Product Change Notification

October, 2012

Bourns® Model SRF1260 & SRF1280 Series Change to the Amount of Epoxy

Figure 2: New -
Epoxy in Four Spots

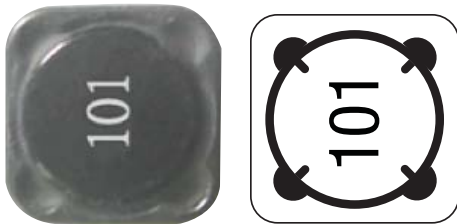
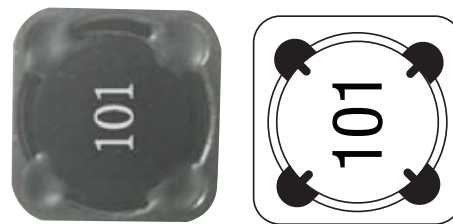
The production process for the Bourns® Model SRF1260 and SRF1280 Series Dual-Winding Shielded Power Inductors will be modified to reduce the amount of epoxy applied between the inductor core and shield. Currently, the inductor core and shield are held together with epoxy that is manually applied completely around the core (see figure 1). The production process will now be automated to apply the epoxy in four spots to bond the core and shield (see figure 2).

This Product Change Notification reflects an anticipated positive change to reliability. The reduction in the amount of epoxy in between the core and shield, which will create free space for material thermal expansion, should help reduce the risk of core cracking during the reflow soldering process.
